# Certificate of Appropriateness

948 N. 34TH ST. Concordia Historic District

This project involves the reconstruction of a front porch.

Front porch sketch

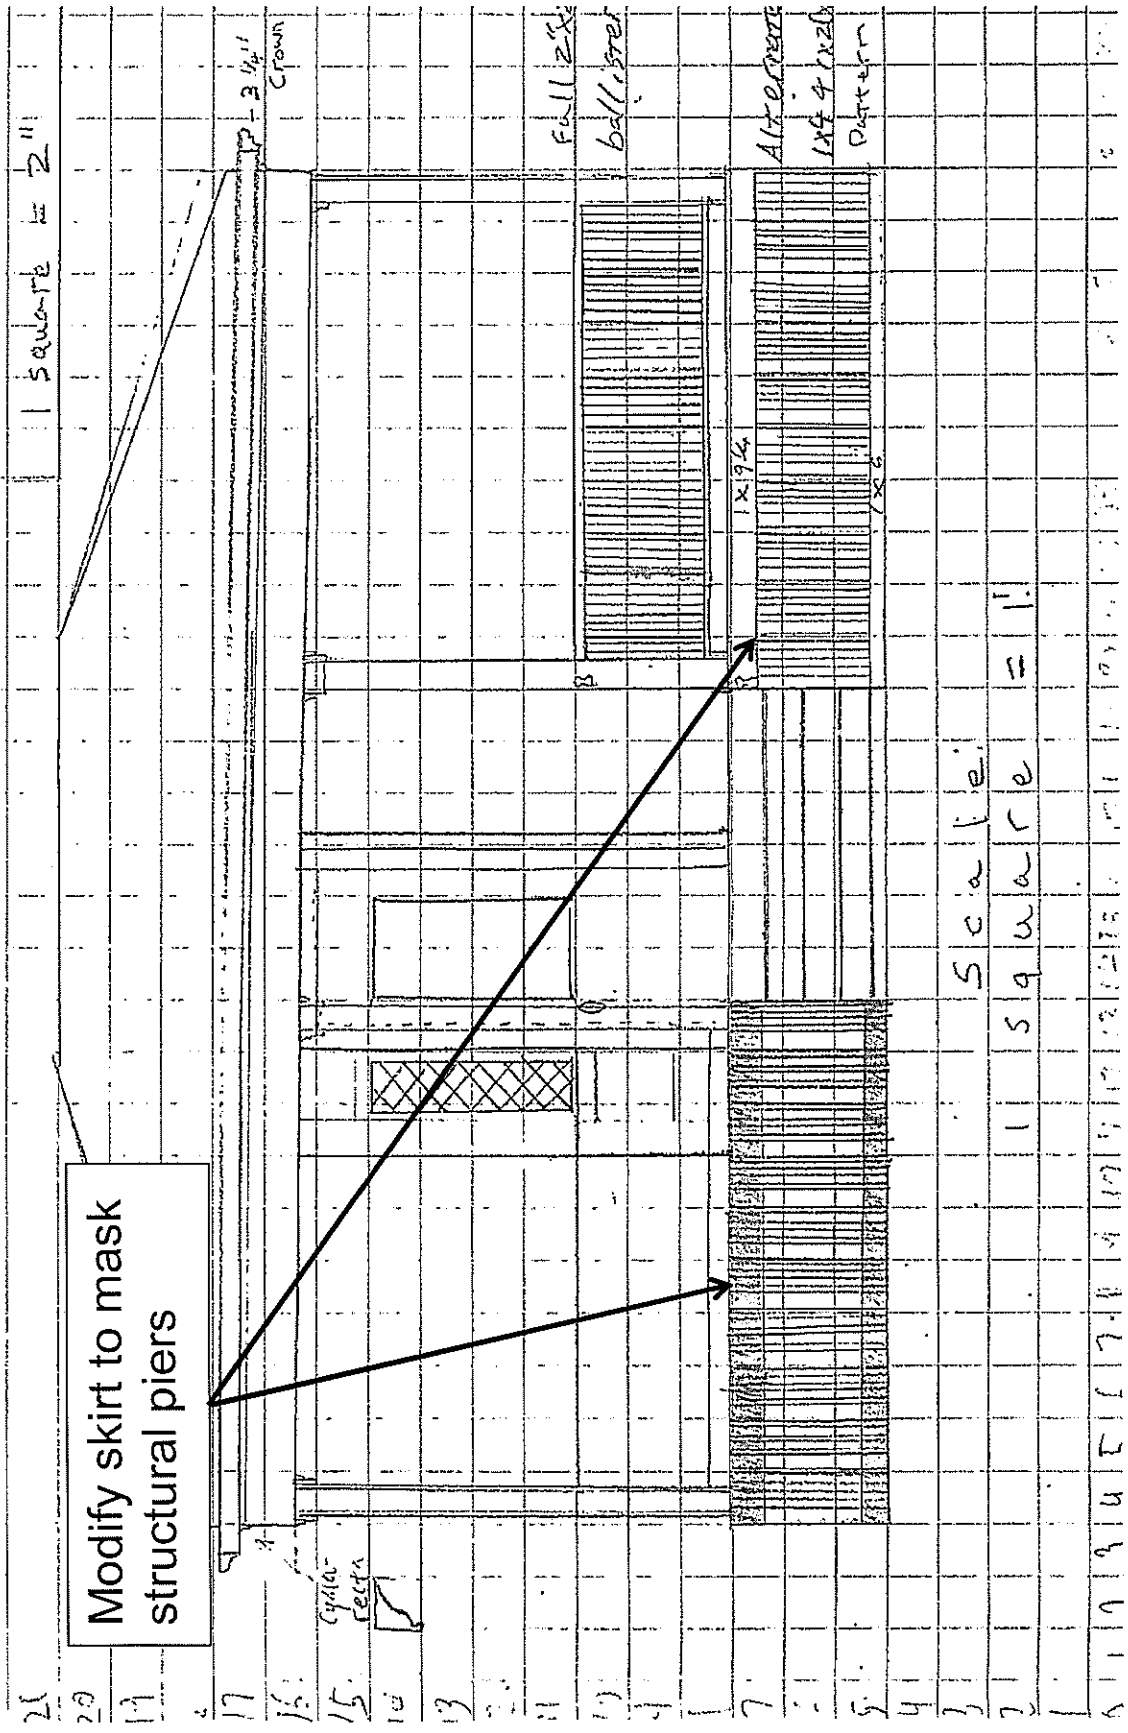
Porch skirting is to be modified to include wider building elements to mask structural piers at foundation.

Modify skirt to mask structural piers
